Appendix F
Other Revisions to IS/MND

Appendix F. Other Revisions to IS/MND

RE: Olinda Last Mile Underserved Broadband Project, Agency Comment Letter Received

**Attachment 2 – Excerpt of Waterway Delineation
Report Figure (Draft IS/MND Appendix D, Page 78)**

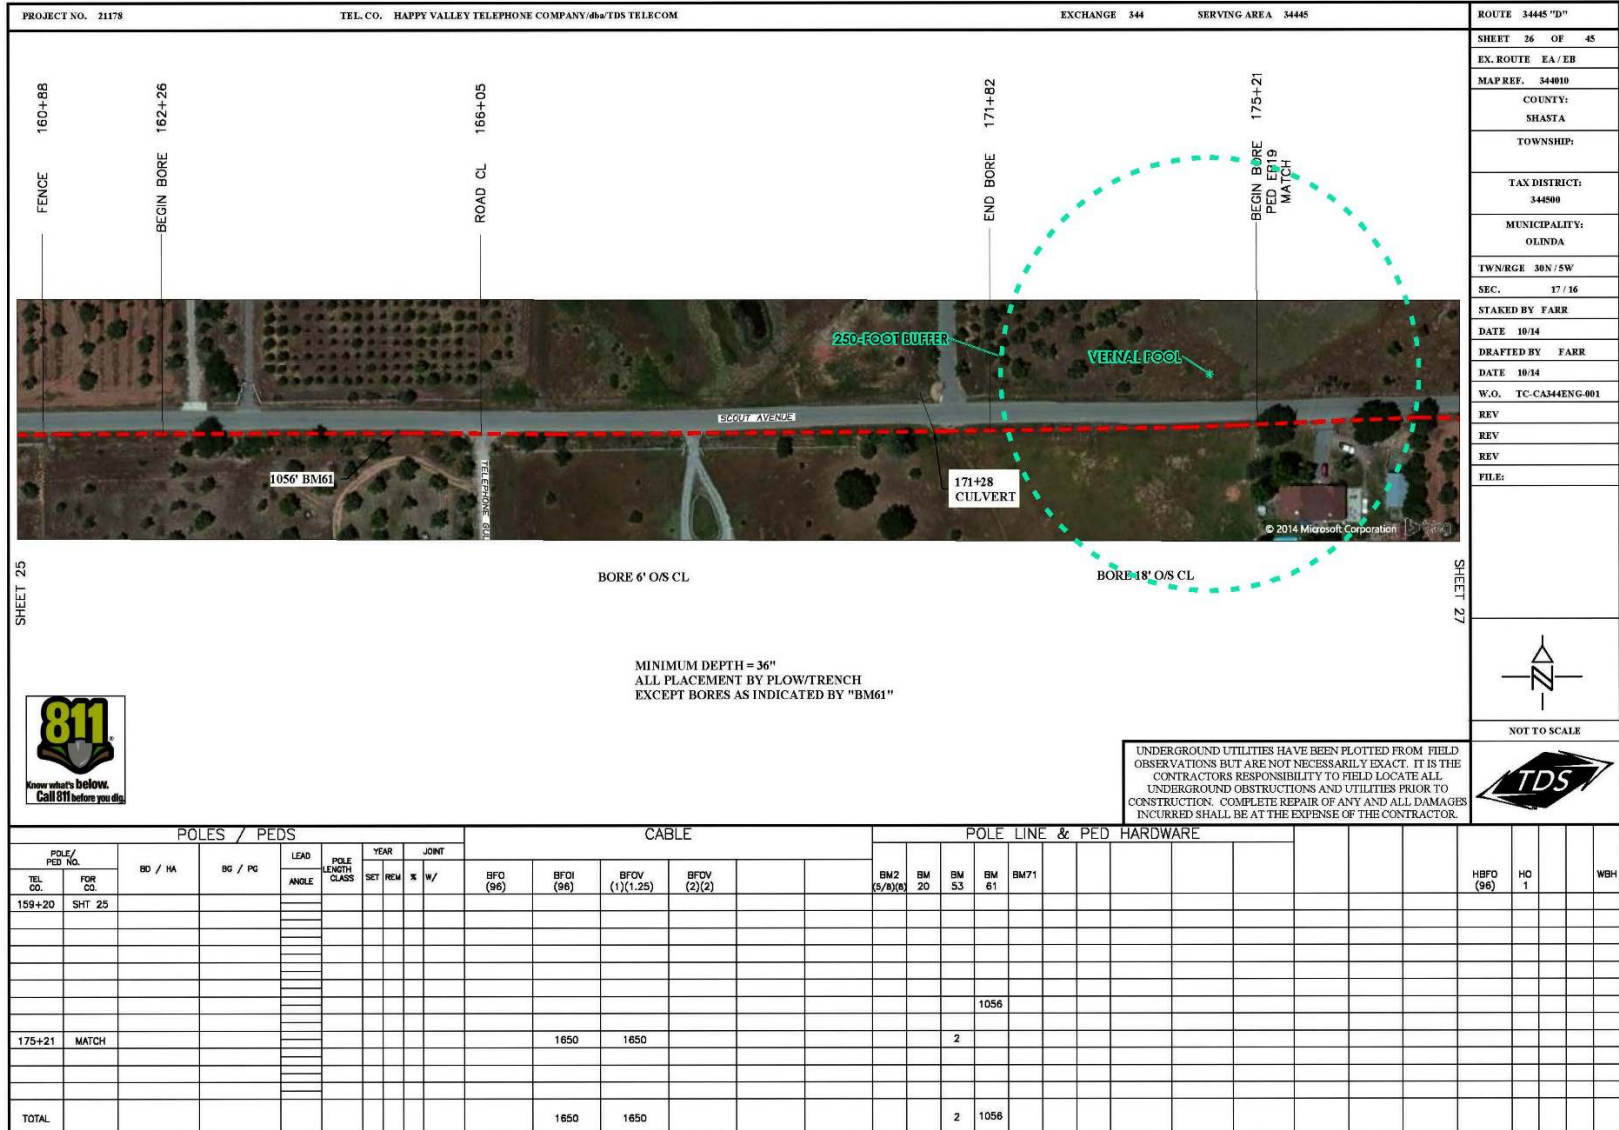
The kmz file provided by CDFW is a data point (See Attachment 1). This data point is located on Scout Avenue, between Telegraph Gulch Road and Olive Street, in the proximity of waterway WW-15 (unnamed tributary to Telephone Gulch), identified on Page 78 of Appendix D of the Draft IS/MND (Waterway Delineation Report [WDR], see Attachment 2). In addition, during review, our findings show that the vernal pool location is within 250 feet of a proposed boring pit location (see Attachment 3).

Relocating boring pits outside of the 250-foot buffer zone shown in Attachment 3 would ensure that bore pits are located at least 250 feet away from the vernal pool, in compliance with Applicant Proposed Measure (APM) BIO-3 (brought forward as mandatory mitigation under mitigation measure (MM) GEN-1). APM BIO-3 states the following:

In order to comply with the mitigation requirement (APM BIO-3 brought forward as mandatory mitigation under MM GEN-1) the Applicant (TDS Telecom) is required to modify the boring pit location adjacent to WW-15 (See Attachments 2 and 3).

The Applicant is required to move the boring location identified within 250 feet from the vernal pool that was identified by CDFW since it is brought forward as mandatory mitigation under MM GEN-1.

Response: The proposed boring site relocation is technically feasible and the project map and staking sheets depicting these changes is attached including a separate file that contains the shape files.
